# Service Bulletin Fuel Systems

Bulletin No.: MSA-3  
Revision No.: 1  
Date: 11/16/90  
Revised: 11/18/91

**SUBJECT: OVERHAUL PERIODS FOR FLOAT CARBURETORS.**

SUBJECT: Carburetor Throttle Body Screw Inspection

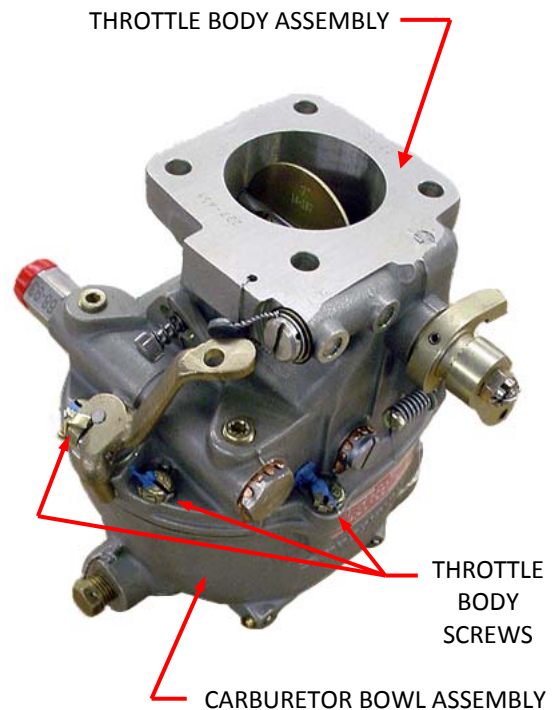
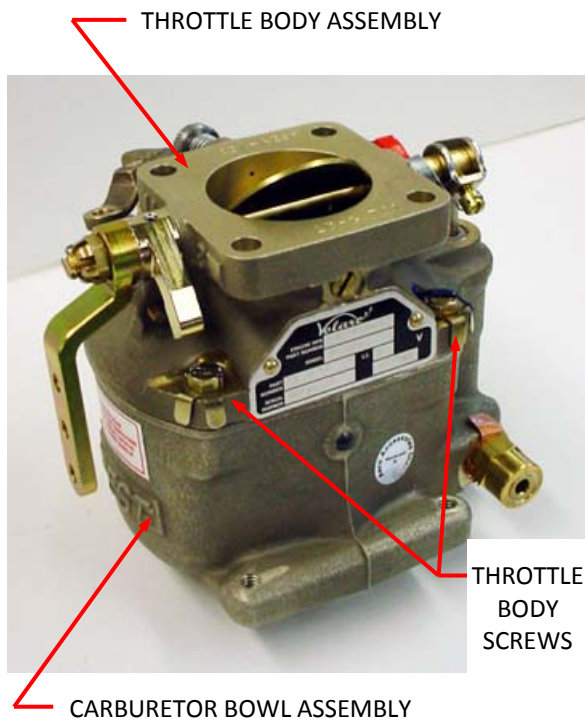
- a) Check the carburetor for evidence of fuel stains on the outside of the bowl along the throttle body / bowl parting line.
- b) Check the bowl for looseness relative to the throttle body by attempting to wiggle or move the bowl relative to the throttle body by hand.

- c) Check each throttle body to bowl screw and lock-tab washer for any sign of looseness by attempting to wiggle the screw head and lock tab washer with your fingers.

**Warning: Do not turn the screws with a tool (a screwdriver or wrench) when checking them it for looseness. Doing so with the lock-tab washers engaged against the screw may bend the lock tabs and compromise the lock-tab washers' effectiveness.**

- d) If there is evidence of fuel stains, looseness of the bowl relative to the throttle body, or loose throttle body to bowl screws, an appropriately rated mechanic, engineer, or repair station must: Remove the carburetor from the engine. In accordance with the appropriate carburetor service manual; remove the bowl from the throttle body. Inspect the threaded holes in the bowl and screws to be sure the threads are serviceable. Install a new body to bowl gasket. Install new lock tab washers. Install and torque the screws in accordance with appropriate specifications. Test the carburetor in accordance with instructions in the appropriate service manual. Secure the lock tab washers by bending the tabs.
- e) Reinstall the carburetor on the engine and rig it in accordance with the applicable engine and airframe service manual instructions.

- Models MA-3™, MA-3A™, MA-3PA™, MA-3SPA™, MA-4™, and MA-4SPA™ have four (4) screws.
- Models MA-4-5™, MA-5™, MA-4-5AA™, MA-6™, and MA-6AA™ have six (6) screws.

**Figure 1**  
**Illustrative Example of Throttle Body Attaching Screws**

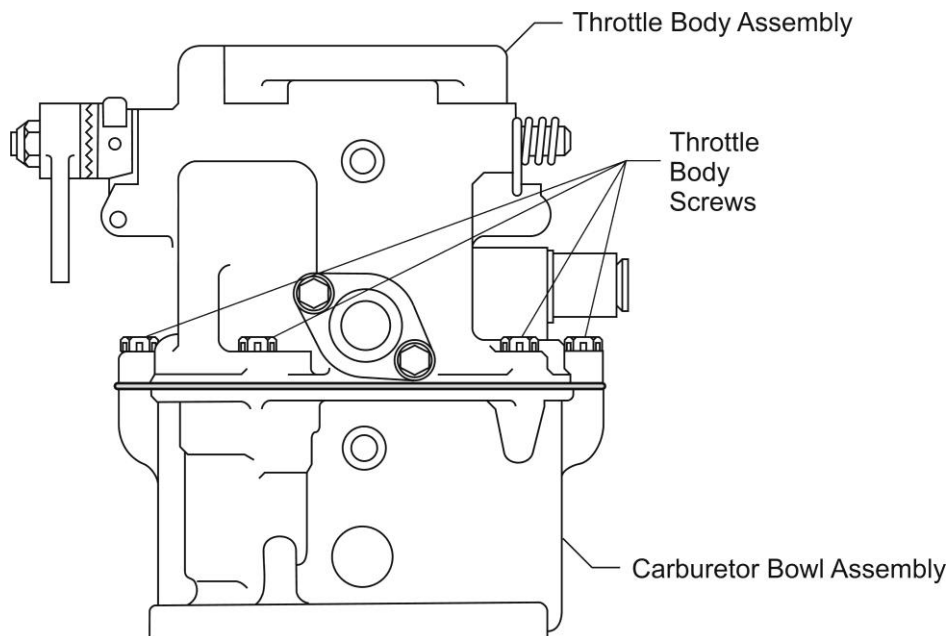
Instances have been reported of leakage through the gasket between the bowl assembly and throttle body of the carburetor, evident by fuel stains in the area of the leak. Leakage of this type can be accompanied by loose screws that attach the bowl and throttle body.

See Figure 1 for illustrative example of the throttle body attaching screws.

1. Examine the carburetor for evidence of fuel stains on the outside of the bowl along the parting line.
2. Complete a check for movement between the throttle body and bowl.
3. Make sure each throttle body-to-bowl attaching screw is secure and not loose by attempting to move the screw and/or locktab washers with your fingers.

**⚠ CAUTION:** IF ANY ATTACHING SCREW IS LOOSE, DO NOT ATTEMPT TO TURN THE SCREW WITH A SCREWDRIVER. IF YOU TURN THE SCREW WITH A SCREWDRIVER, IT COULD DAMAGE THE LOCK WASHERS AND INCREASE THE LIKELIHOOD THAT THE SCREWS WILL BECOME LOOSE.

4. If there is evidence of fuel stains, movement between the throttle body and bowl, or the throttle body-to-bowl attaching screws are loose then remove the carburetor in accordance with the applicable engine and airframe service manuals. Send the carburetor to a qualified repair station for troubleshooting and repair. Reinstall the carburetor in accordance with the applicable engine and airframe service manuals.
5. Make an appropriate logbook entry showing compliance with this Service Bulletin.

Models MA-3A, MA-3PA, MA-3SPA, and MA-4SPA have four screws. Models MA-4-5, MA-4-5AA, and MA-6AA have six screws.
